RECORD DRAWING
BASED ON CONTRACTOR MARKUPS,
NOT FIELD SURVEY.

BW2 JOB NO. 10-1424 AND 11-1471

RECORD DRAWING

WASTEWATER SYSTEM IMPROVEMENTS
WASTEWATER GRAVITY SEWER AND LIFT STATION

WASTEWATER SYSTEM IMPROVEMENTS
WASTEWATER GRAVITY SEWER AND LIFT STATION
LIFT STATION - MECHANICAL PLAN
CITY OF LUCAS

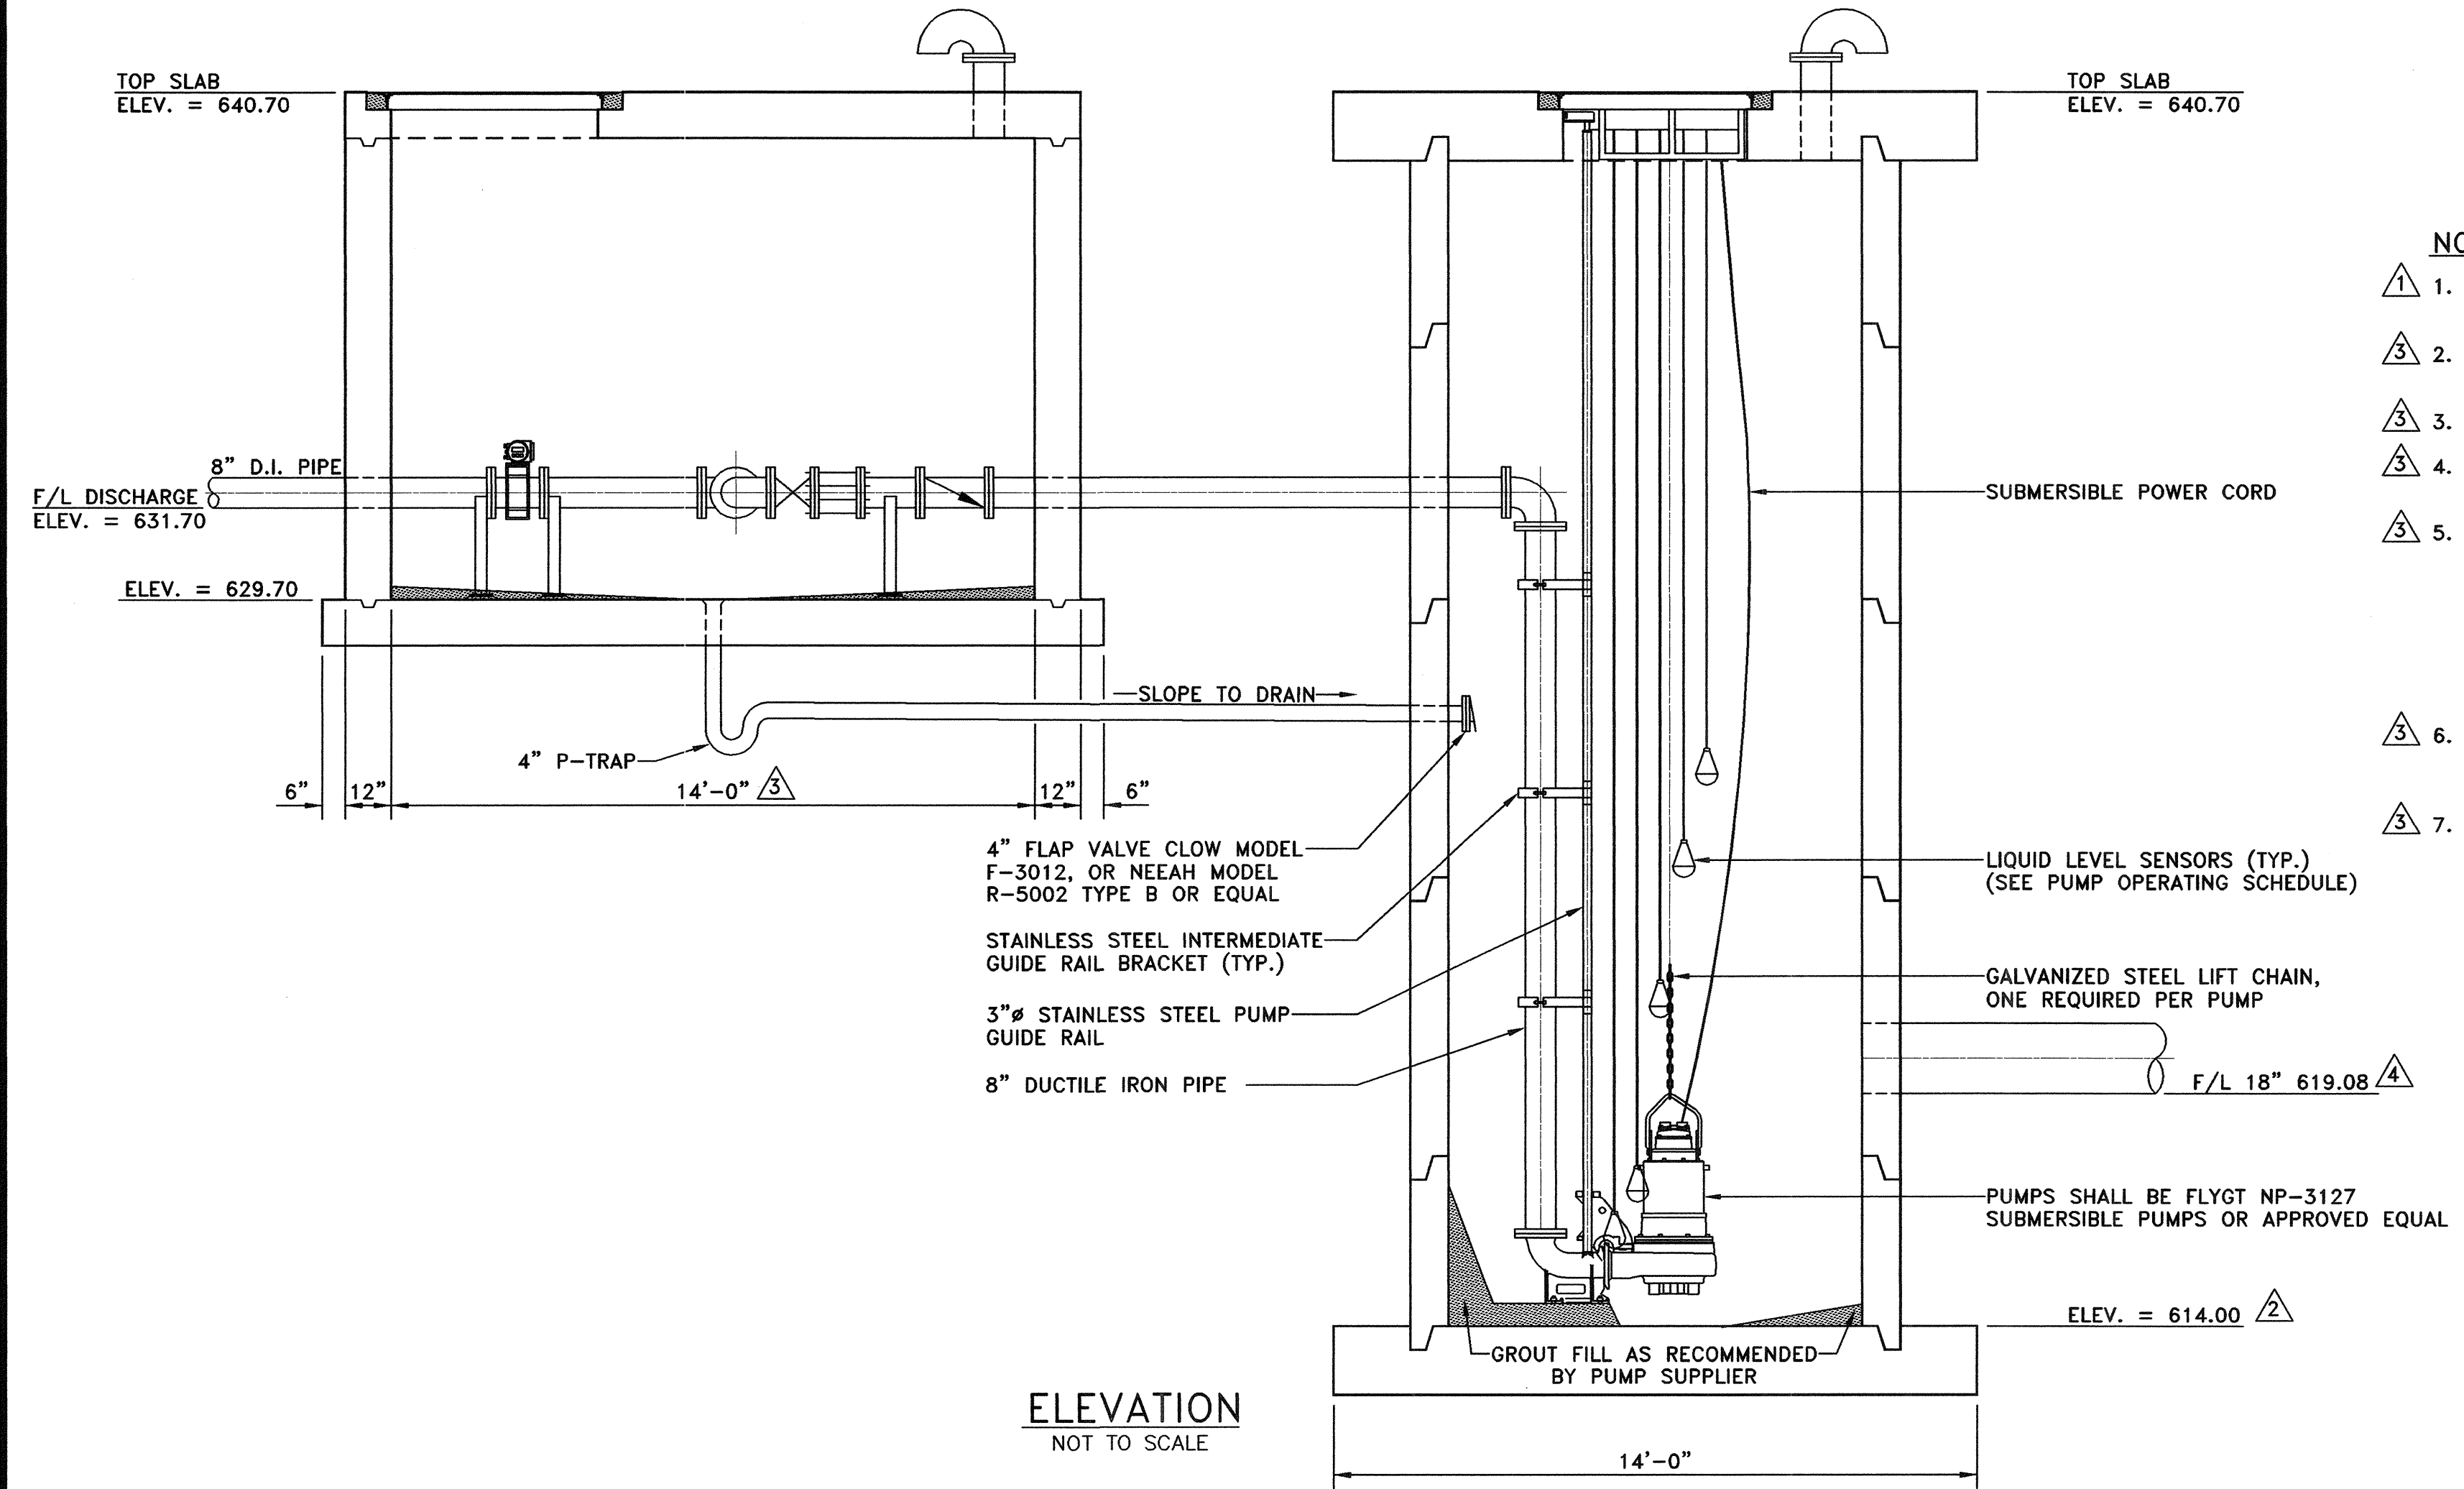
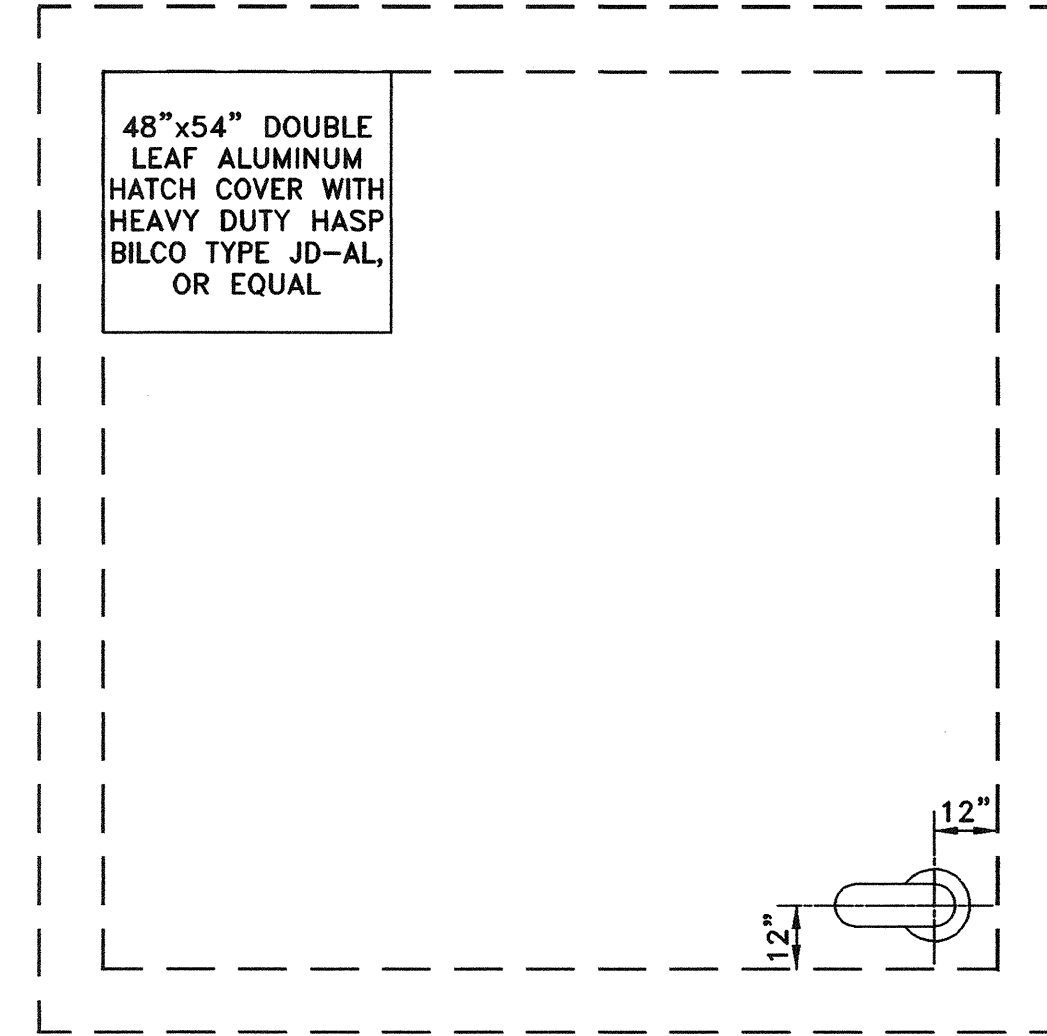
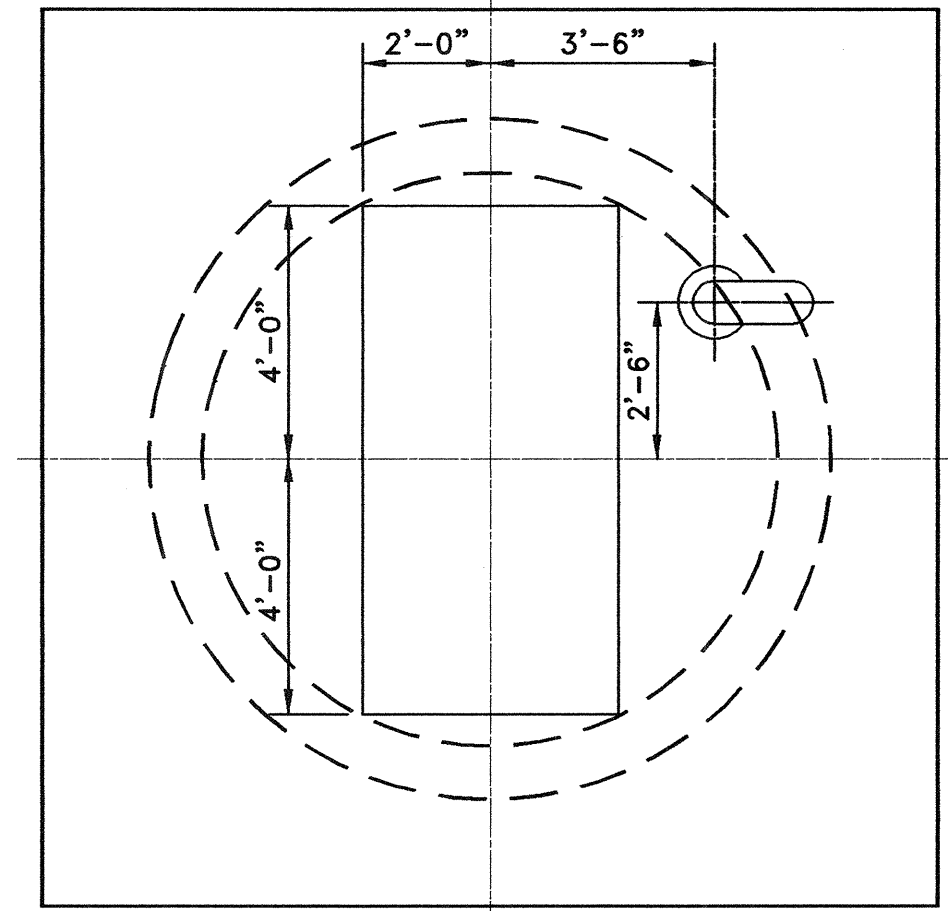
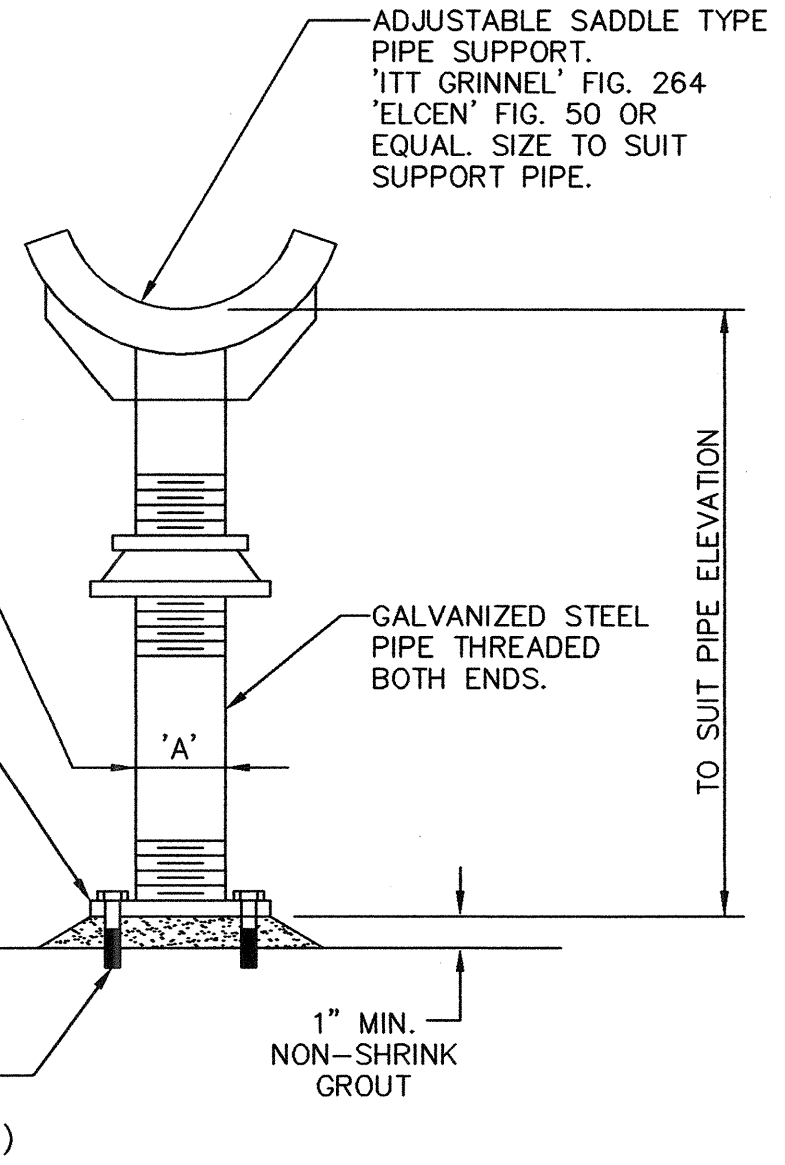
- NOTES:**
1. REVISED THE BOTTOM SLAB OF THE LIFT STATION FROM AND ELEVATION OF 616.70 TO AN ELEVATION OF 614.00.
 2. THE DUCTILE IRON PIPE SHALL BE CEMENT LINED ON THE INSIDE AND PAINTED ON THE OUTSIDE PER THE PIPE MANUFACTURES RECOMMENDATIONS.

7. REVISE THE INSIDE DIMENSIONS OF THE VALVE VAULT FROM 10' BY 10' TO 14' BY 14'. THE REINFORCING STEEL IN THE TOP SLAB AND THE BOTTOM SLAB SHALL BE INCREASED ACCORDINGLY TO ACCOMMODATE THE REVISED DIMENSIONS OF THE VALVE VAULT.

NO.	DATE	REVISION	REVIEWED
6			
5			
4	9/17/12	REVISED F/L PER FIELD CONDITIONS	MRB
3	7/13/12	REVISED PER ADDENDUM NO. 5	MRB
2	7/13/12	REVISED PER ADDENDUM NO. 4	MRB
1	7/13/12	REVISED PER ADDENDUM NO. 2 AND NO. 4	MRB
